DAVIS
PARTNERSHIP
ARCHITECTS

ADDENDUM NO: 03

Date Issued: December 9, 2015

**Re: Red Rocks Community College
Student Recreation Center**
Construction Documents, Dated November 9, 2015
Architect's Project No. 15803.00

Sheet Title:
**TELECOM RISERS
DIAGRAM**

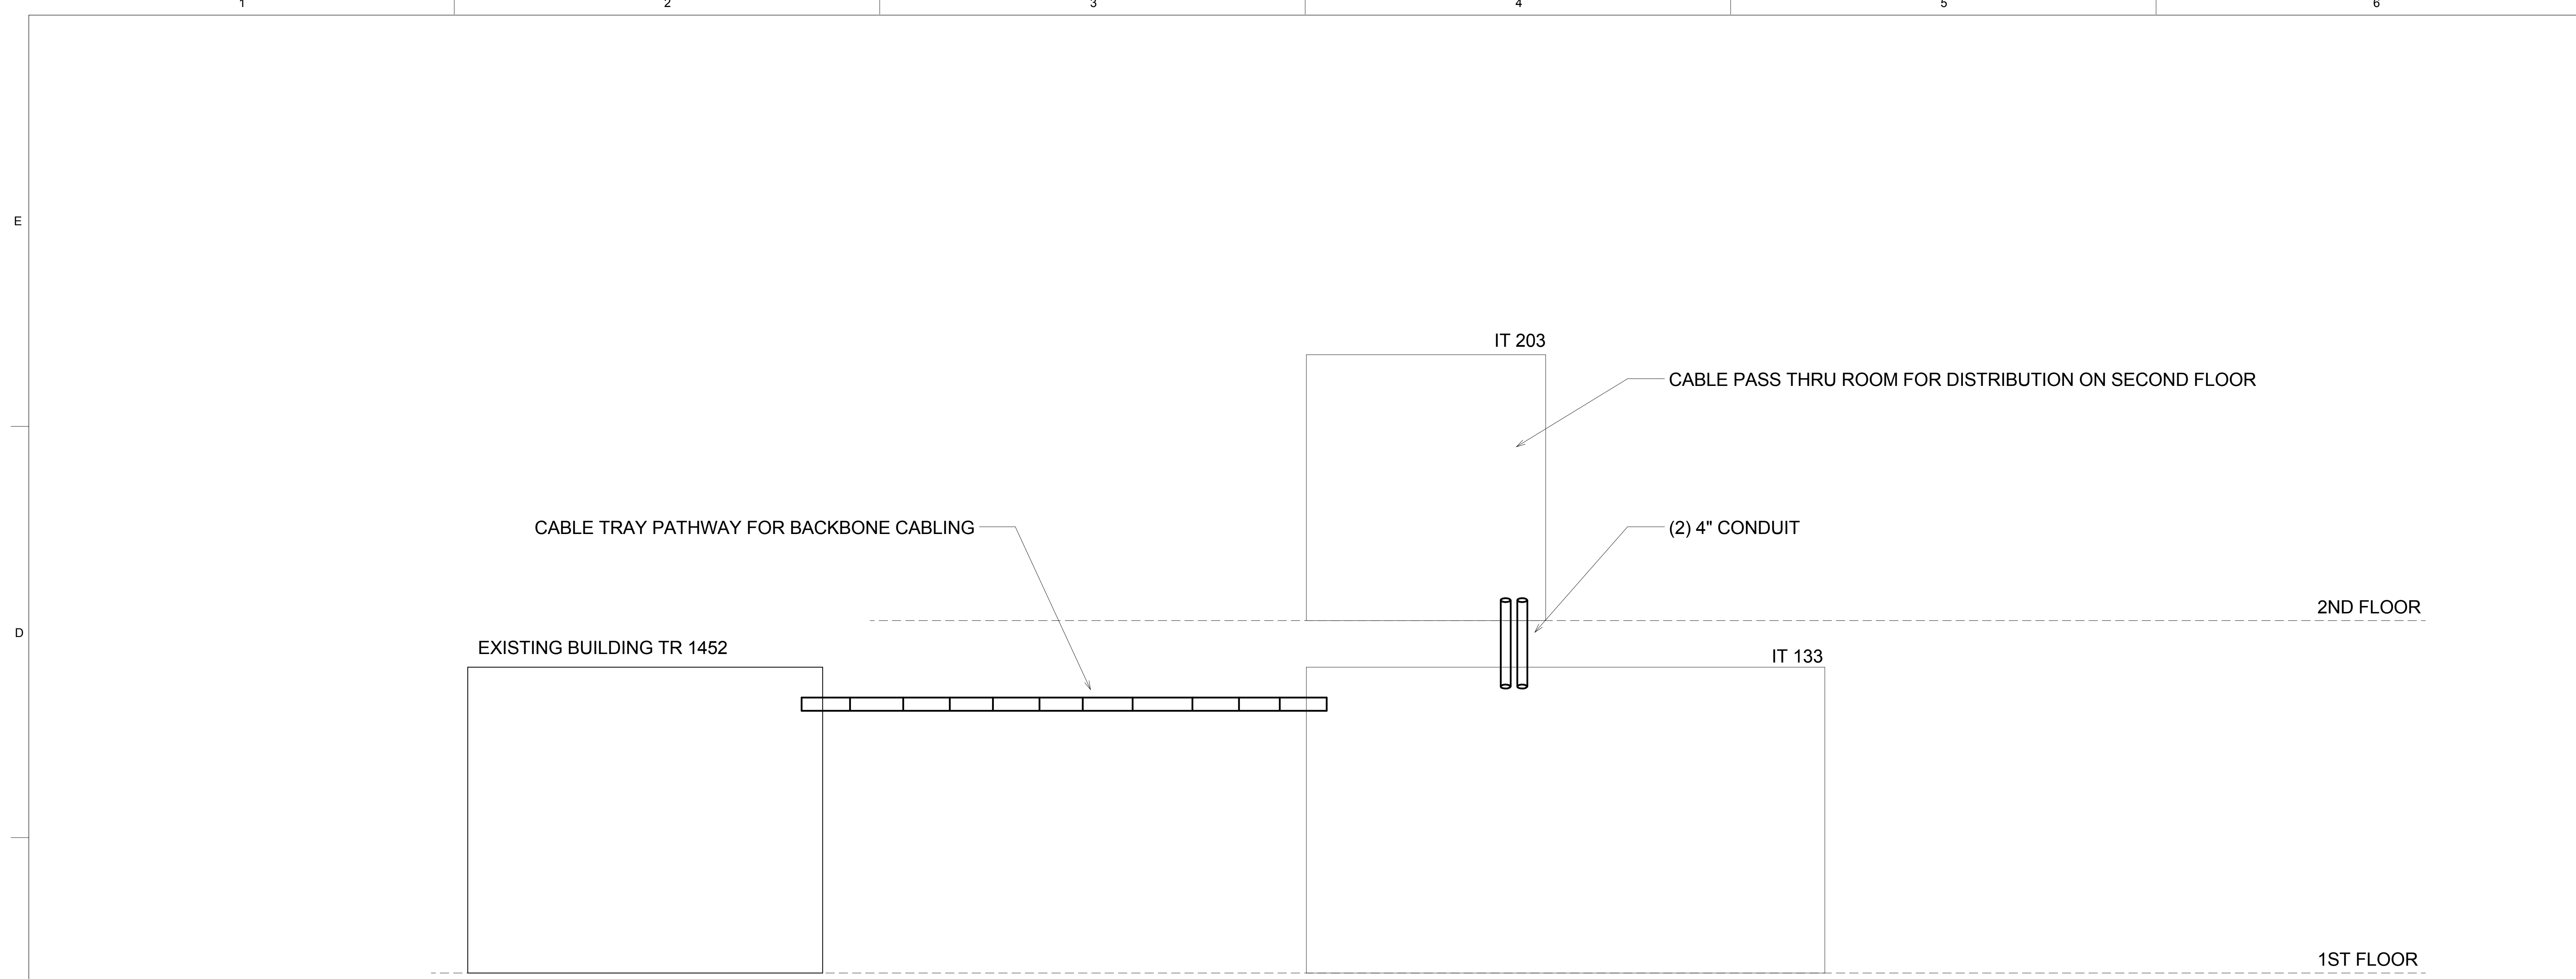
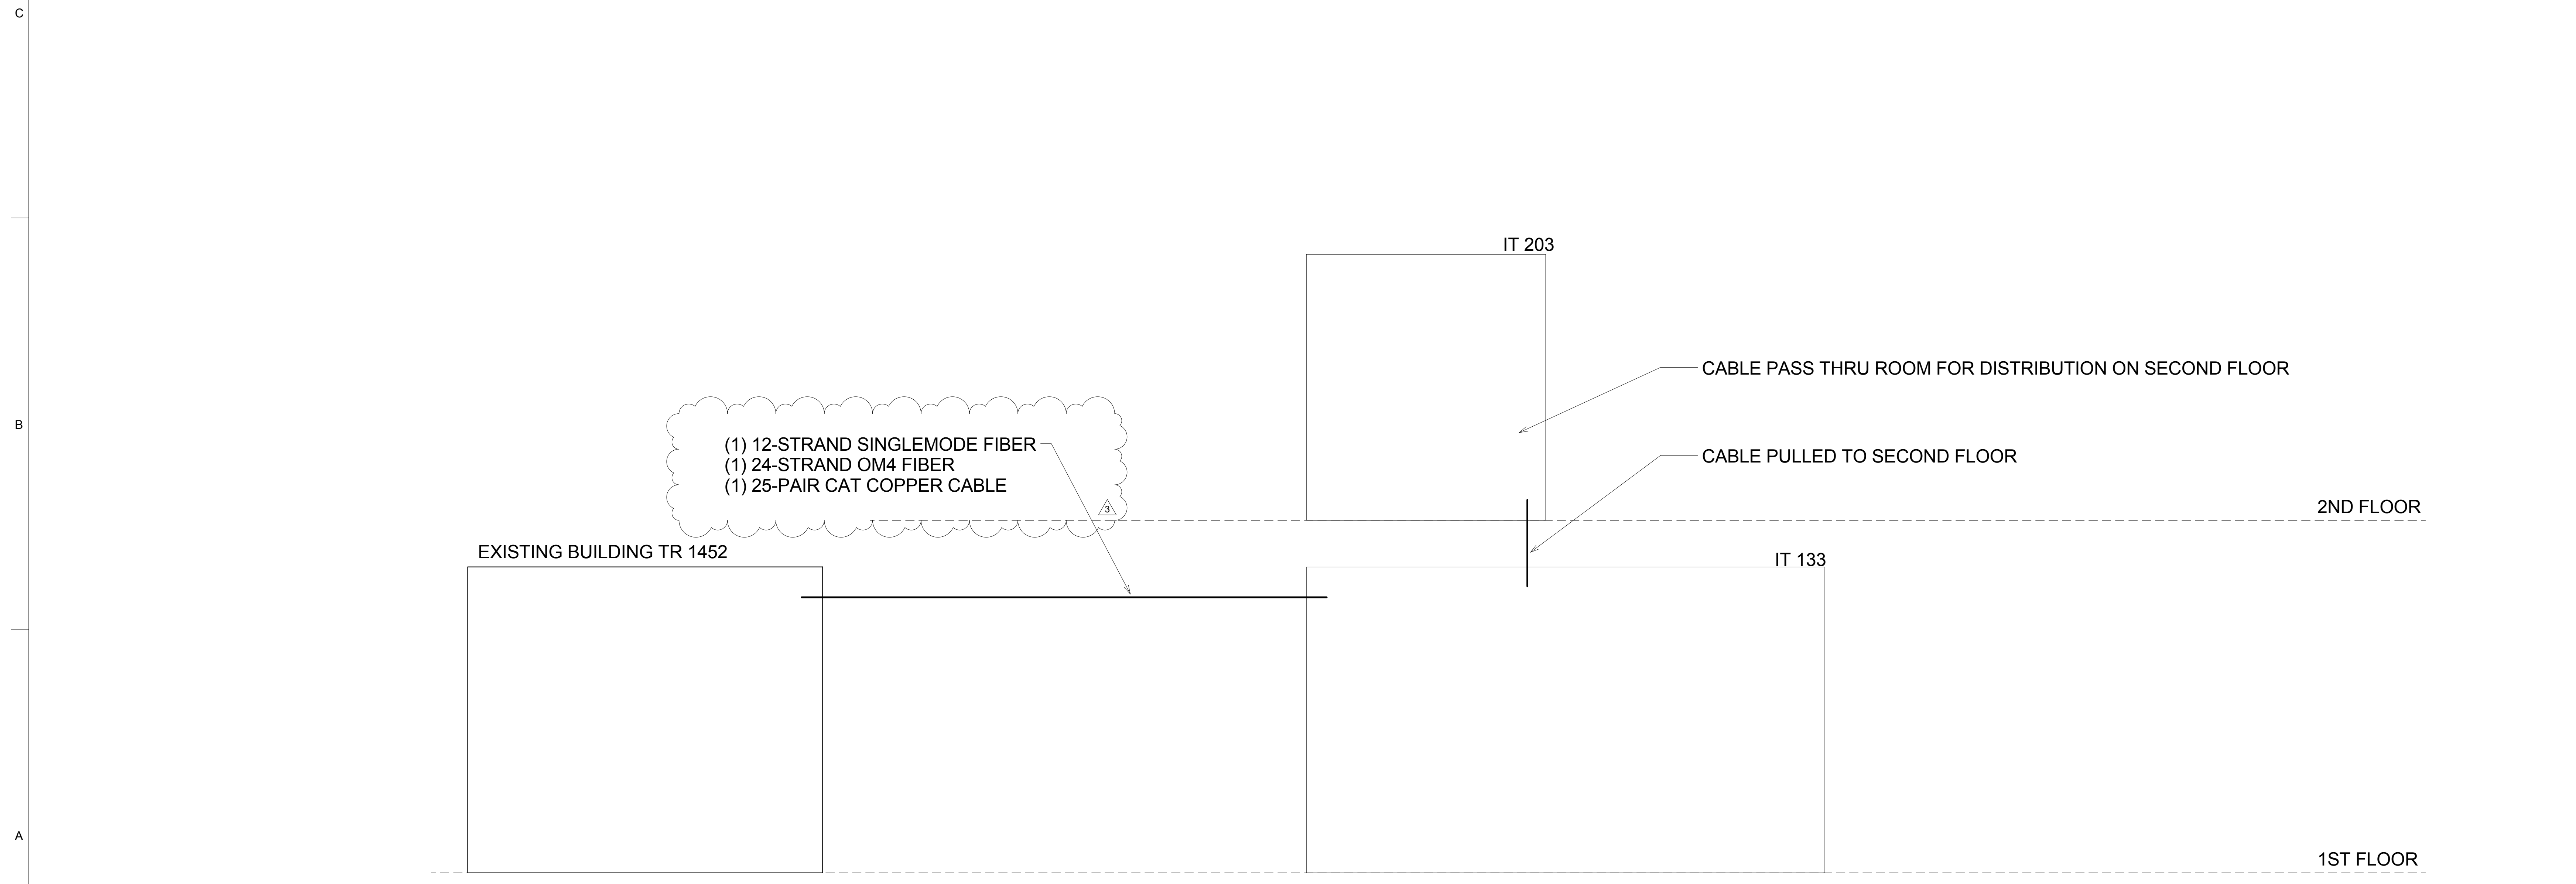
- ADD. #3-34. Drawing sheet TT-300 shows (1) 24 Strand OM4 fiber and the project manual specify TE ND&I warranty.
1. Page 27 1323 -8 and 9 specify Systimax 12/12 SM/OM4 fiber, please clarify fiber type. **SMW RESPONSE: (1) 12-Strand SingleMode Fiber, (1) 24-Strand OM4 Fiber, and (1) 25-pair CAT Copper Cable needed for backbone.**

- ADD. #3-40. On TT 300 Cable Riser Diagram. What is the distance from IT 133 to TR1452? **SMW RESPONSE: Please refer to as-built drawings. T2.00, T2.01, T2.02 attached for Reference Only**

ADD. #3-91. TT-300 – Modified Backbone Cabling to IT 133

1. What are we connecting ? (Possibly the 50pr copper cable reference on TT-300?) **SMW RESPONSE: Connect to 25 pr copper referenced on Addendum 3 drawing TT-300.**
2. Where is the existing 600pr currently located? (Possibly in room TR 1452?) **SMW RESPONSE: 600pr does not need to be connected to room. Connect 25 pr as shown on Addendum 3 drawing TT-300.**
